PERMIT

SEWAGE DISPOSAL SYSTEM

HOWARD COUNTY HEALTH DEPARTMENT

PROPERTY OWNER Kenneth & Karen Rodney Mullinix

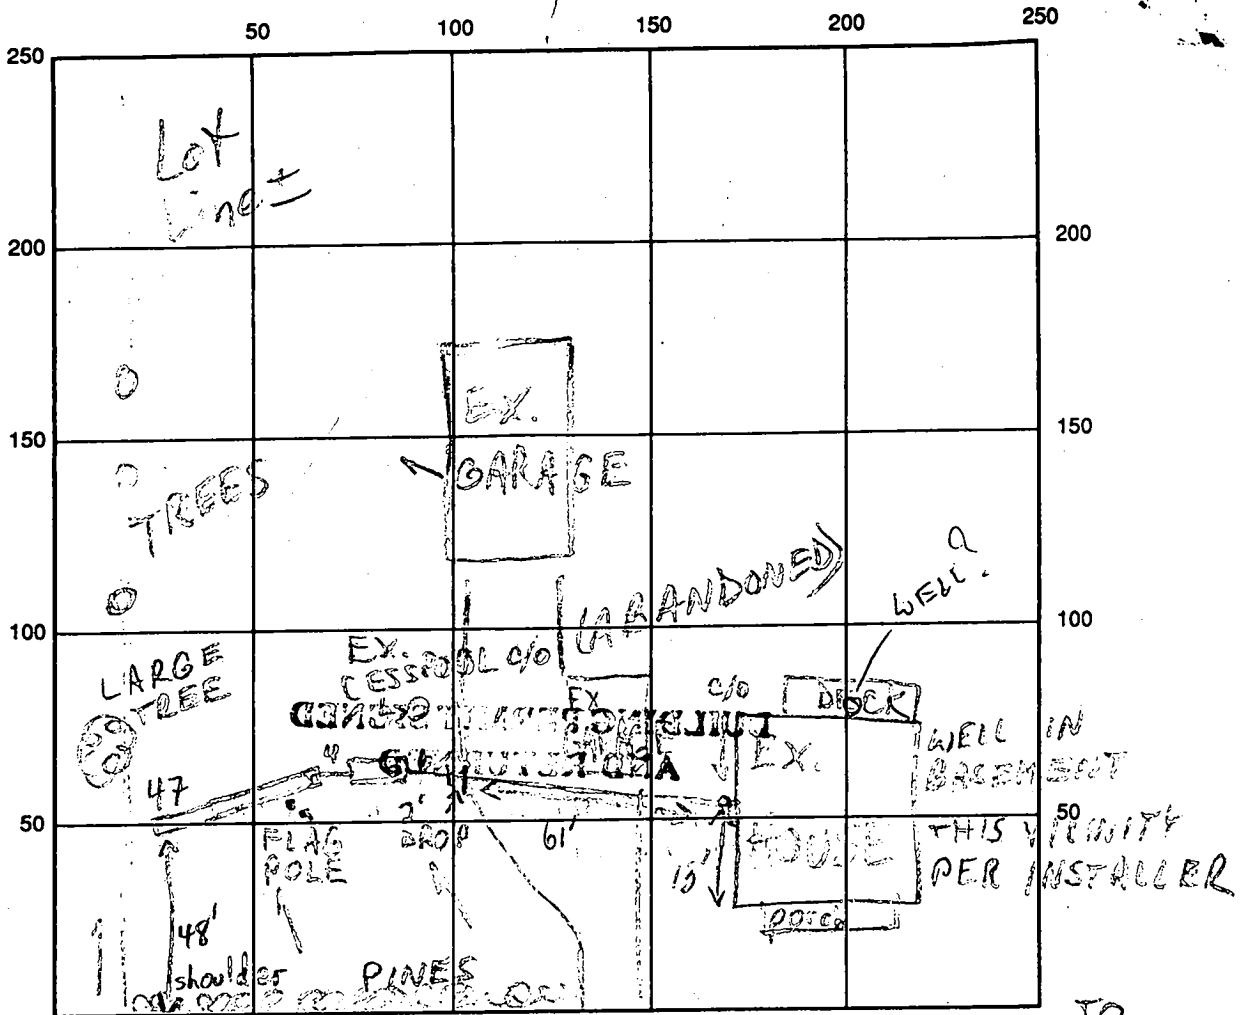
REMARKS: OK TO MAKE 7500-INSR - CONTRACTOR REPORTS SOILS GOOD 3'-16' DEEP.

OK TO PROCEED WITH TRENCH INSTALLATION TO 9' (CW) 4/10/96

4/10/96 #2 INSTALLER REPORTS 7 min perc's AT 3' AND 9'.

LENGTH PREV. ACCEPTED BY CW (ABOVE), COMPLETE HOUSE CONN (MR)

4/10/96 #3 OK TO COVER ALL /SOILS ARE ORGE/RED LOAM <5%

FRAGS) MR

BP 00145595 @ 16038 ED WAYFIELD RD
 OWNER: KENNETH R. MULLINIX

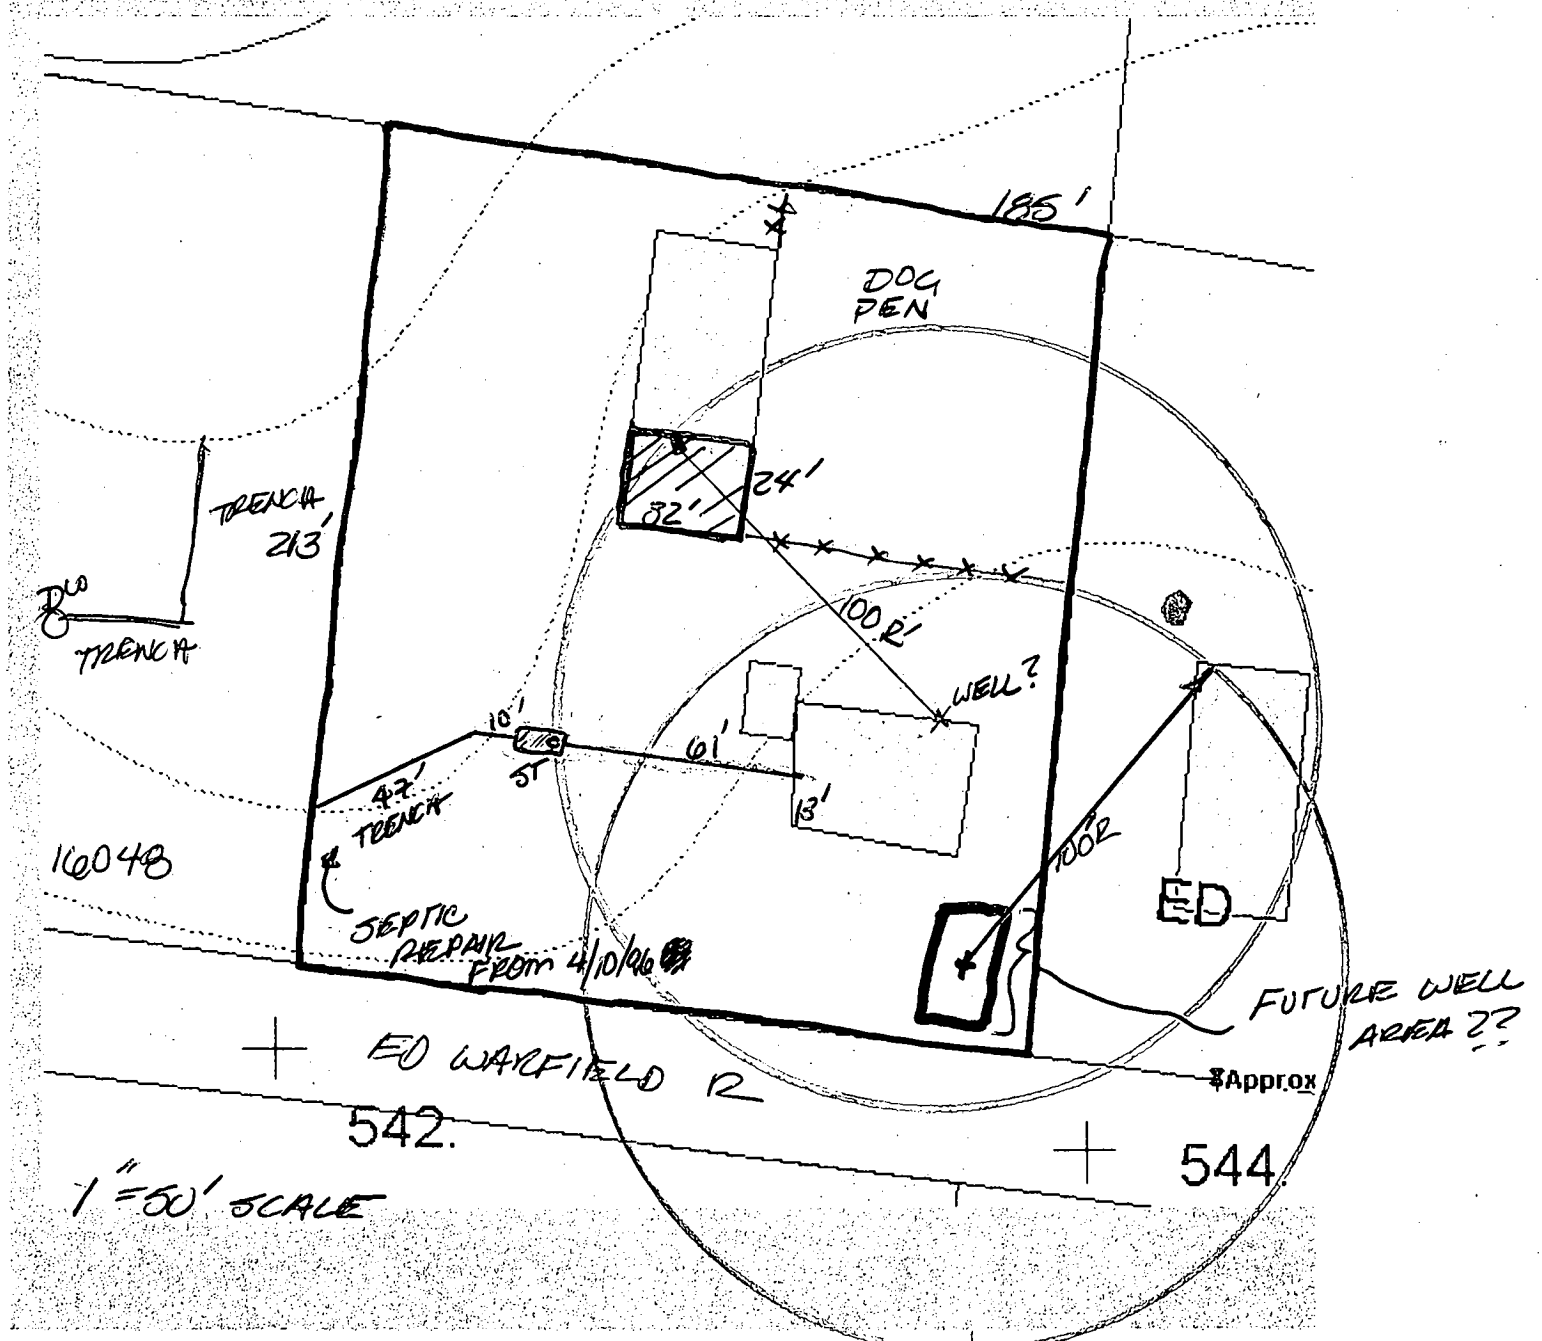
PROPOSED GARAGE FOR THIS BUILDING PERMIT

DO NOT THROW AWAY (FA) 1/2/04

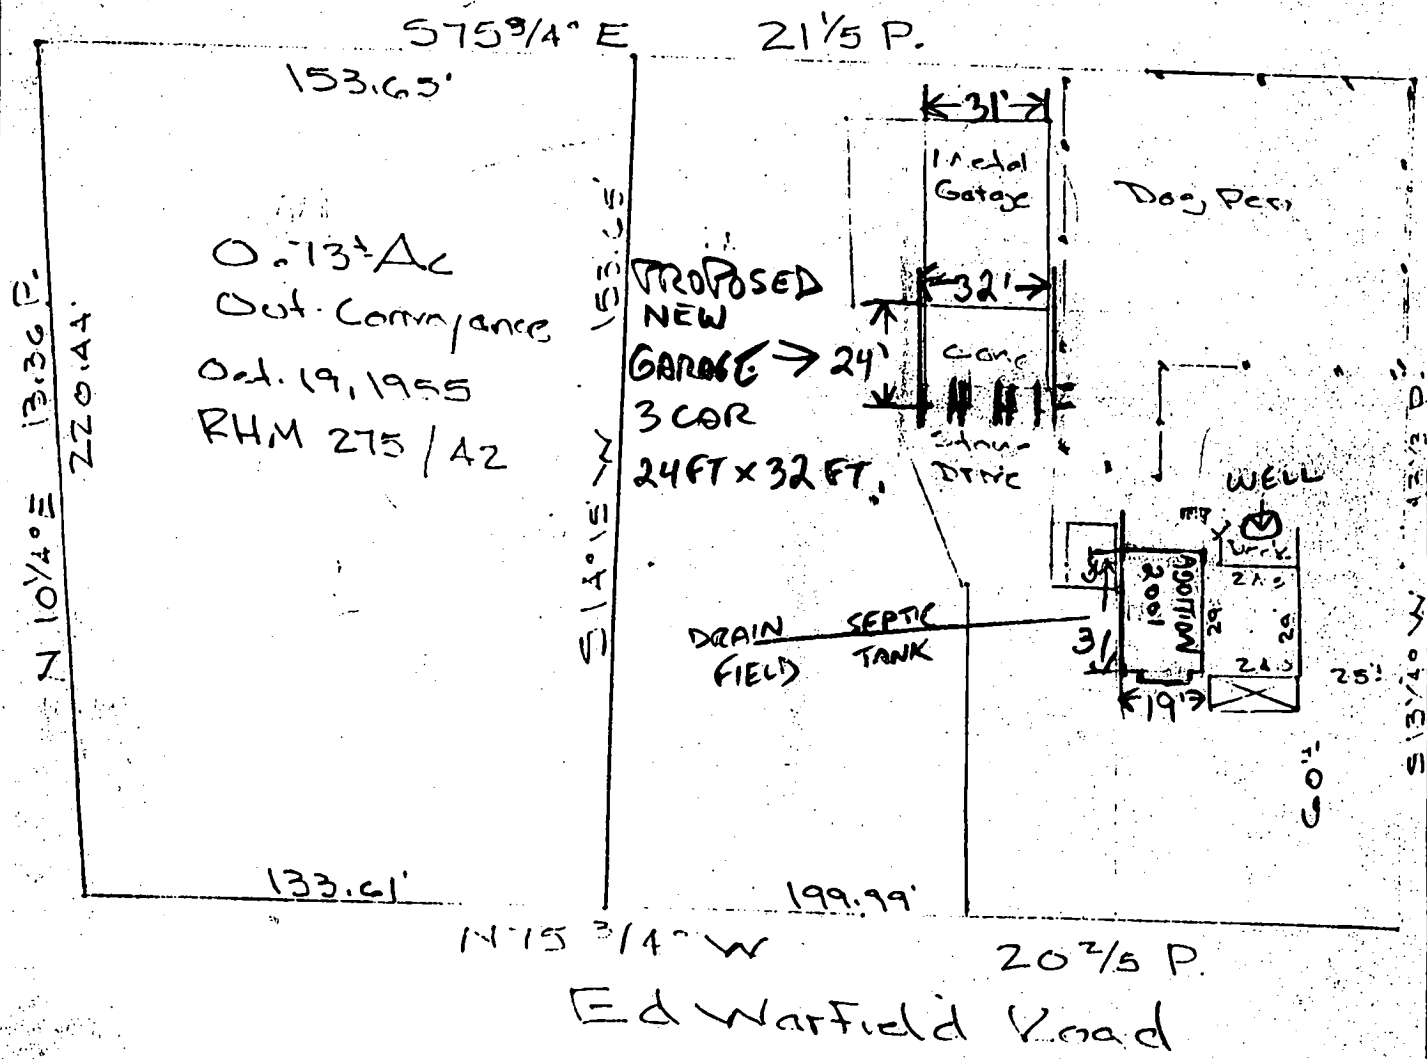
It appears that enough area may be available for future repairs on this lot next to garage & below repair that occurred in 1996. Also dog pen area may provide additional ^{septic} repair area if future well area is placed on front of ~~the~~ house (FA) 1/2/04

DATE: August 29, 1972
 SCALE: ONE INCH Equals 50 FEET.
 LOCATION: SURVEY of:
 16038 Ed Warfield Road
 Howard County, MARYLAND.

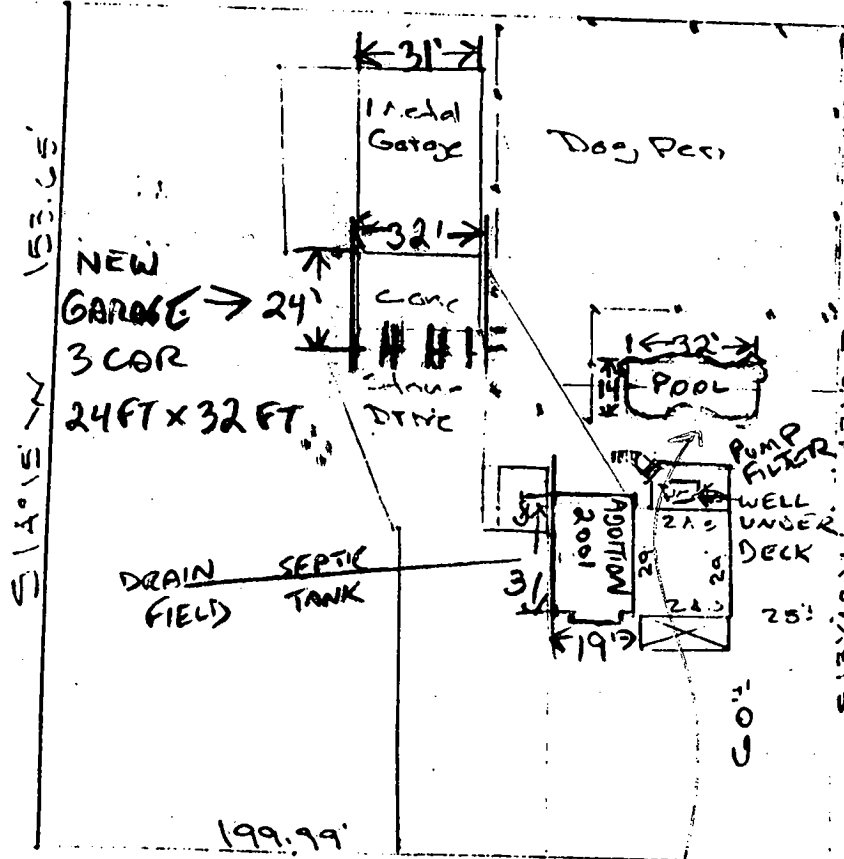
BPO0143371
 PROPOSED
 POOL
 loc.
 OK
